PG&E Letter DCL-00-007

Docket No. 50-275, OL-DPR-80
Diablo Canyon Unit 1
Supplement to License Amendment Request 99-03, Unit 1 Reactor Core Thermal
Power Uprate

**ENCLOSURE G OF
PG&E LETTER DCL-99-170**

MARK-UP OF FINAL SAFETY ANALYSIS REPORT UPDATE

DIABLO CANYON UNITS 1 AND 2
FIGURE 15.1-1
OVERTEMPERATURE AND OVERPOWER DELTA-T PROTECTION

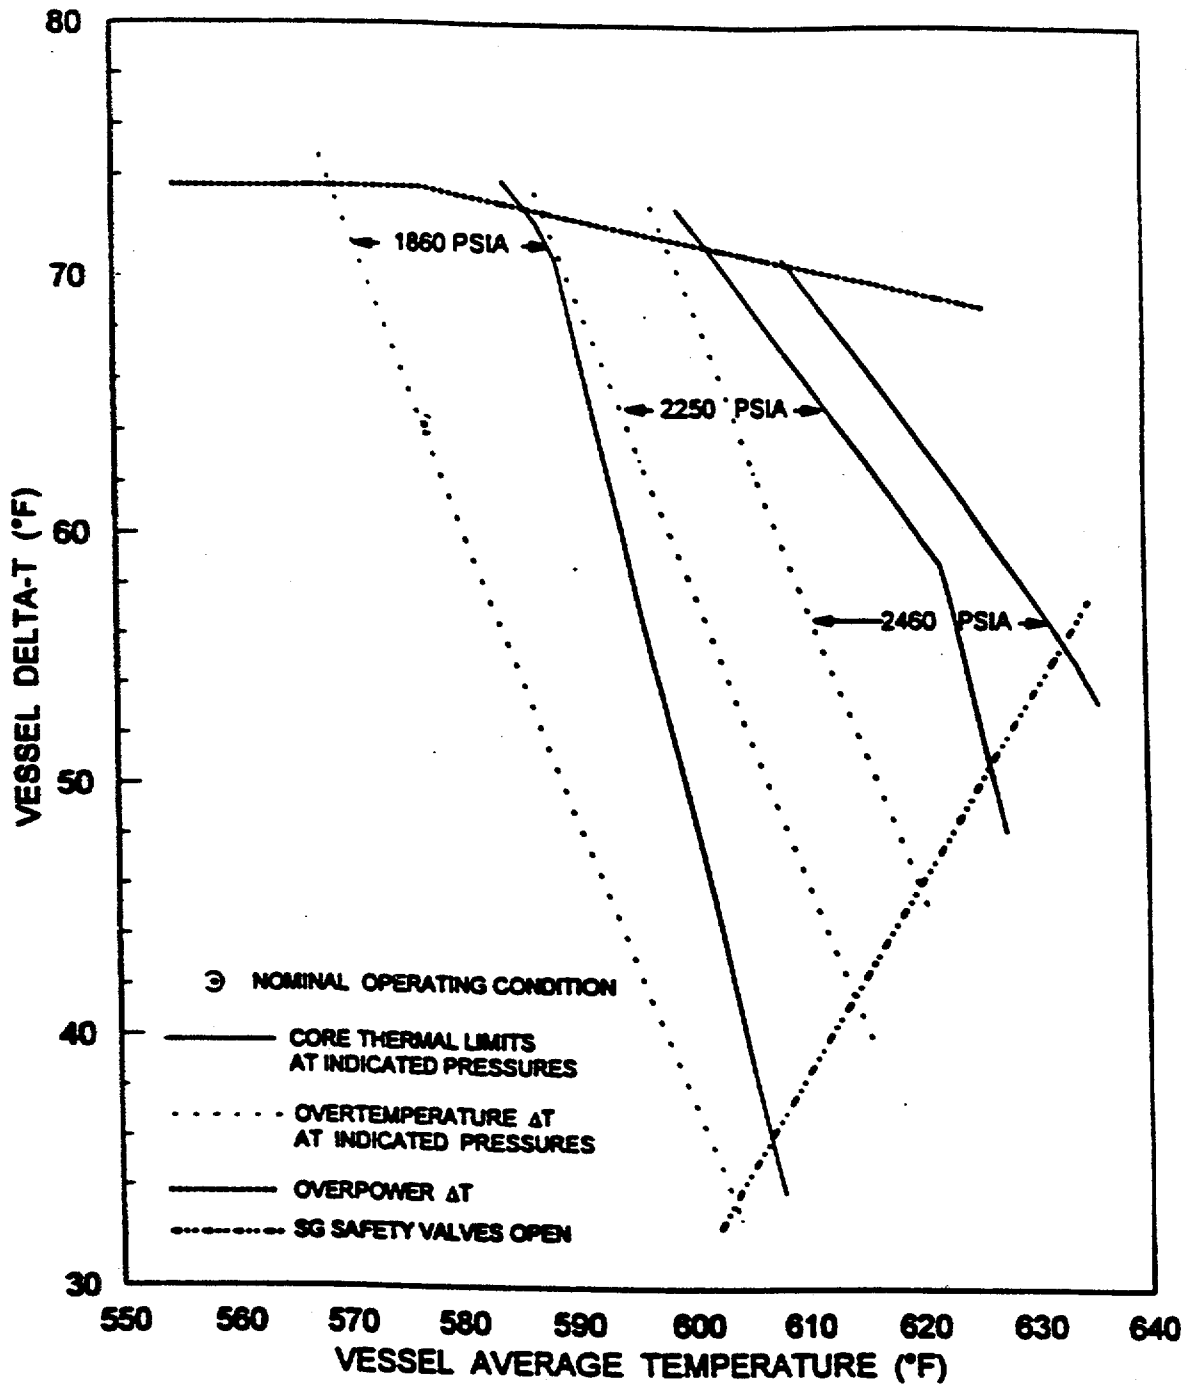
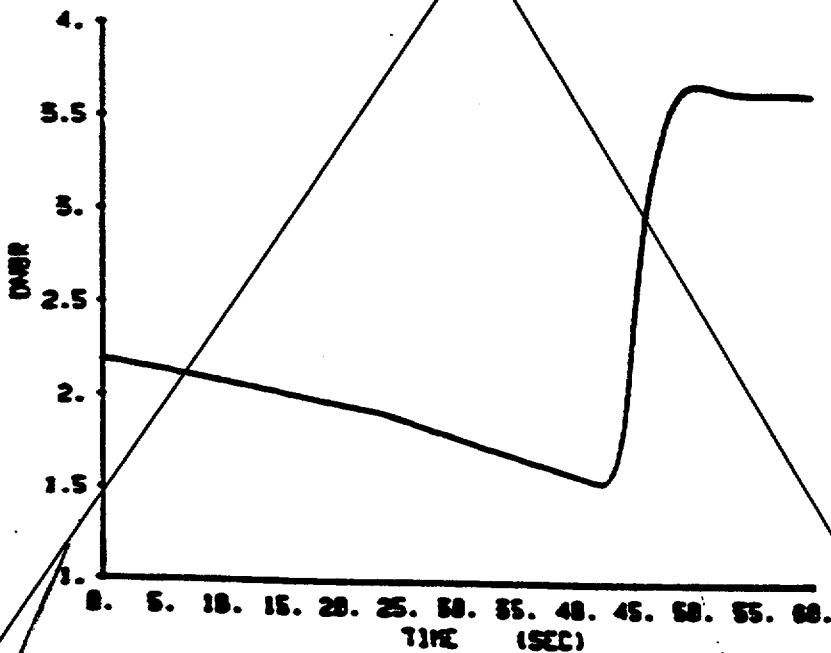
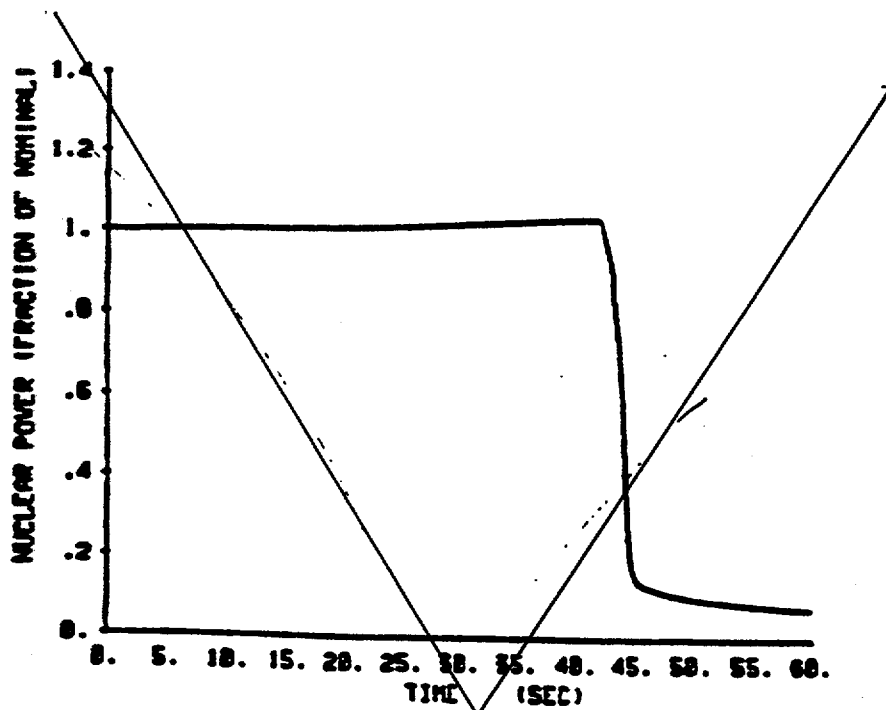
*Remove and
Replace with
the
Following*

DIABLO CANYON UNITS 1 AND 2
 FIGURE 15.2.12-1
 NUCLEAR POWER AND DWR
 TRANSIENTS FOR ACCIDENTAL
 DEPRESSURIZATION OF REACTOR
 COOLANT SYSTEM

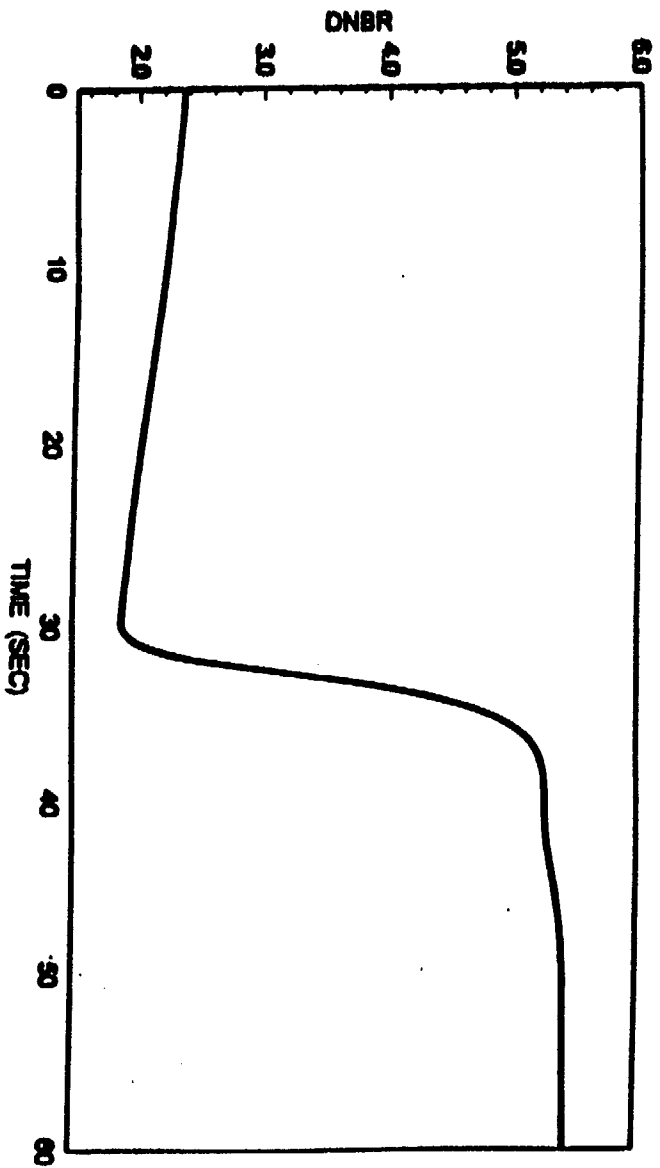
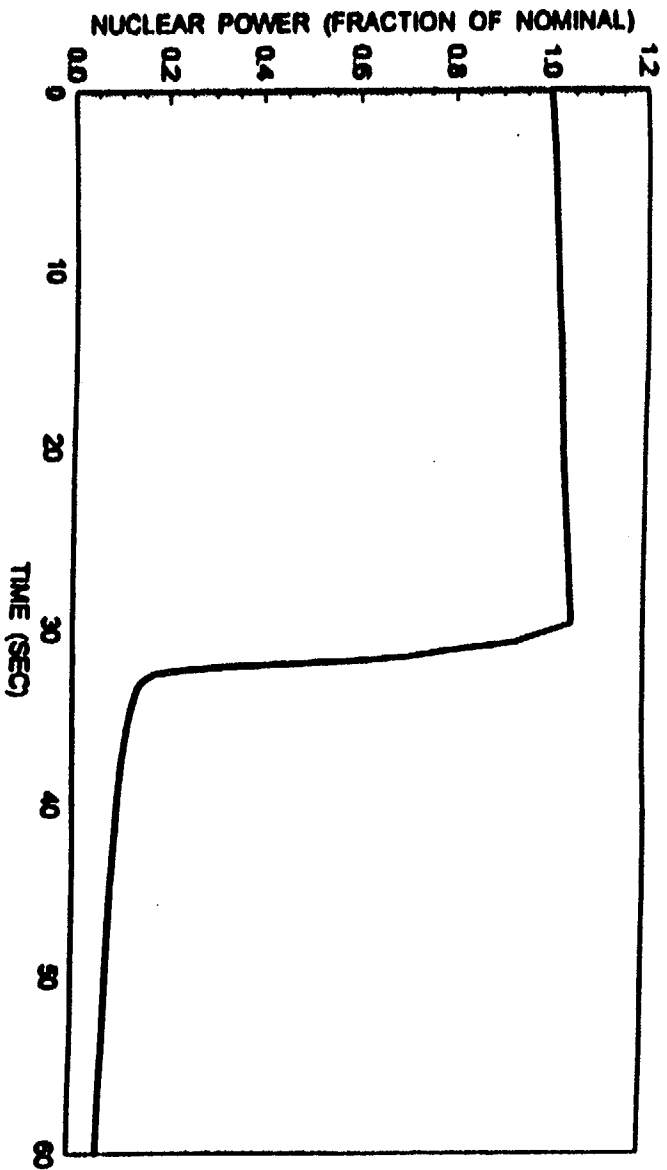
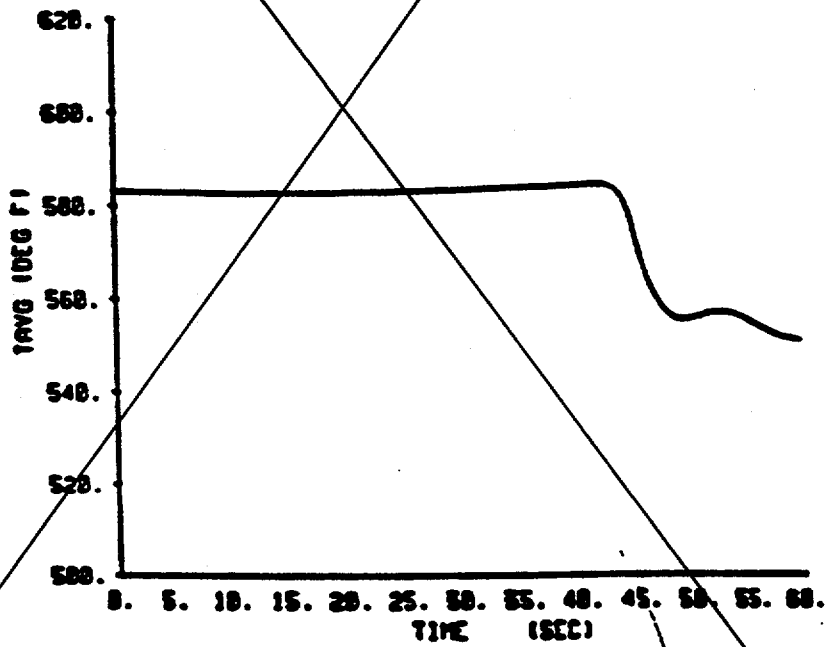
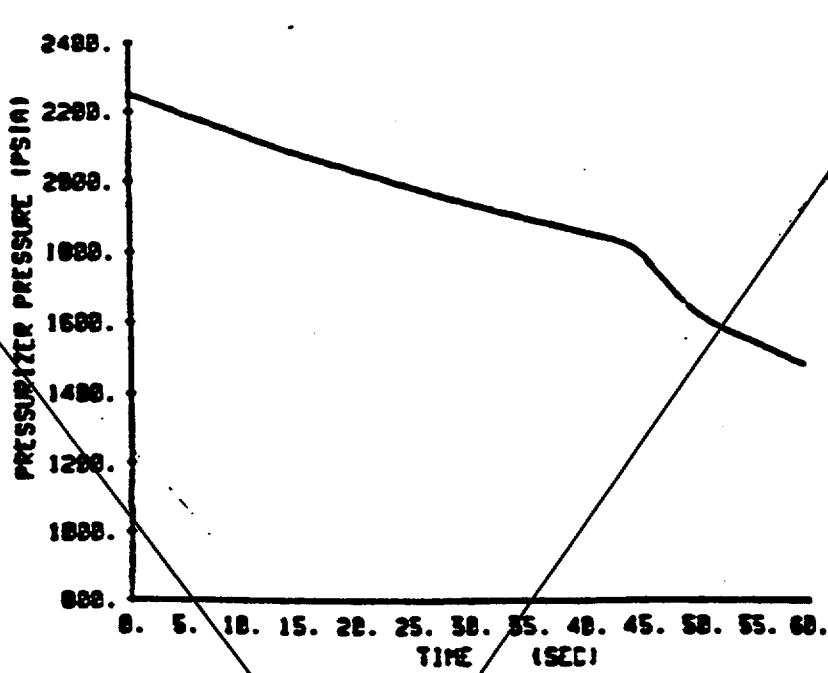
Figure 15.2.12-1 illustrates the flux transient following the RCS depressurization accident. The flux increases until the time reactor trip occurs on ~~Low-Pressurizer~~ Pressure Overtemperature ΔT , thus resulting in a rapid decrease in the nuclear flux. The time of reactor trip is shown in Table 15.2-1. The pressure decay transient following the accident is given in Figure 15.2-12-2. The resulting DNBR never goes below the safety analysis limit value as shown in Figure 15.2.12-1.

Replace with the following

DIABLO CANYON UNITS 1 AND 2
FIGURE 15.2.12-2
PRESSURIZER PRESSURE AND
VESSEL AVERAGE TEMPERATURE
TRANSIENTS FOR ACCIDENTAL
DEPRESSURIZATION OF REACTOR
COOLANT SYSTEM

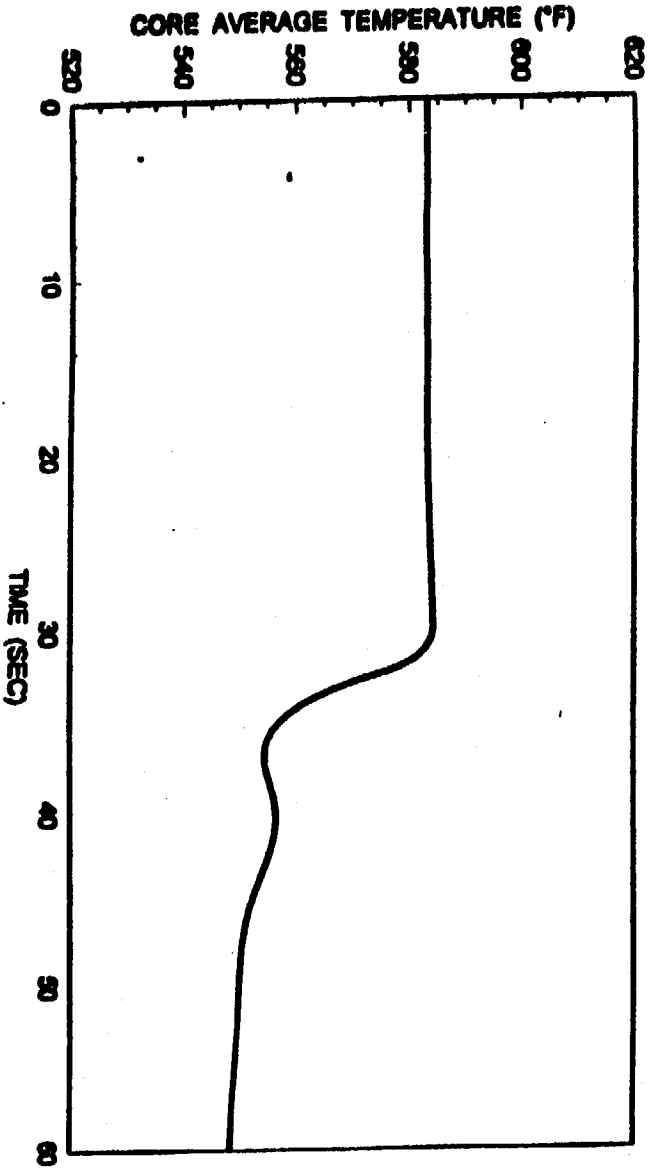
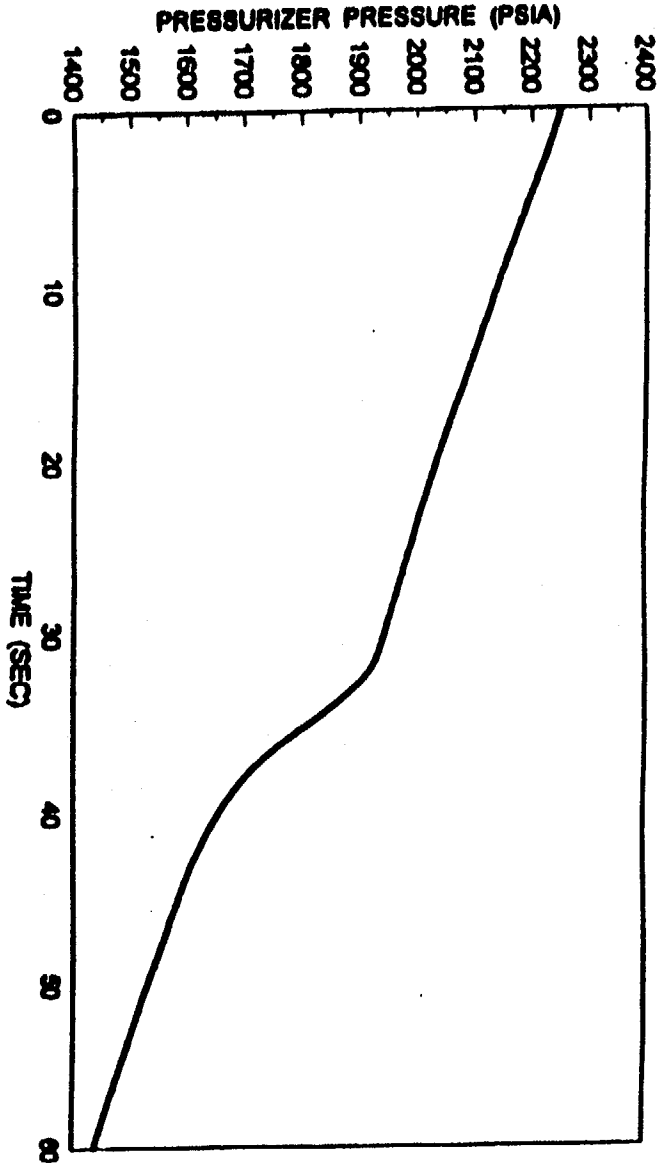
Replace with the Following

Safety Injection Flowrate for Small Break LOCA	DIABLO CANYON UNITS 1 and 2
	Figure 15.3-1

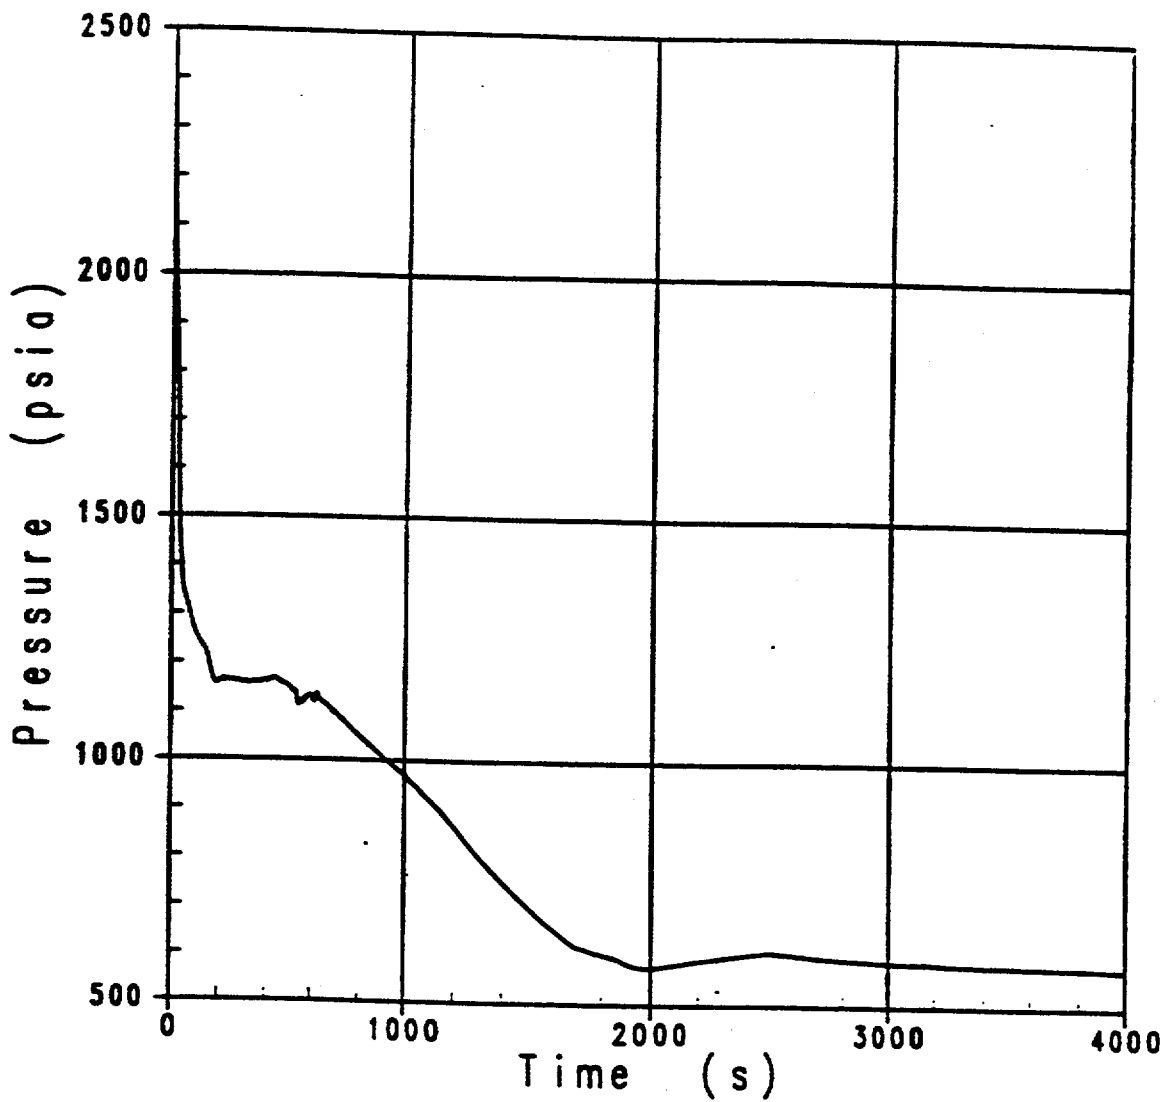
Remove SBLOCA Figures 15.3-1 through 15.3-14f
Replace with following Figures 15.3-1 through 15.3-15-DCPP2
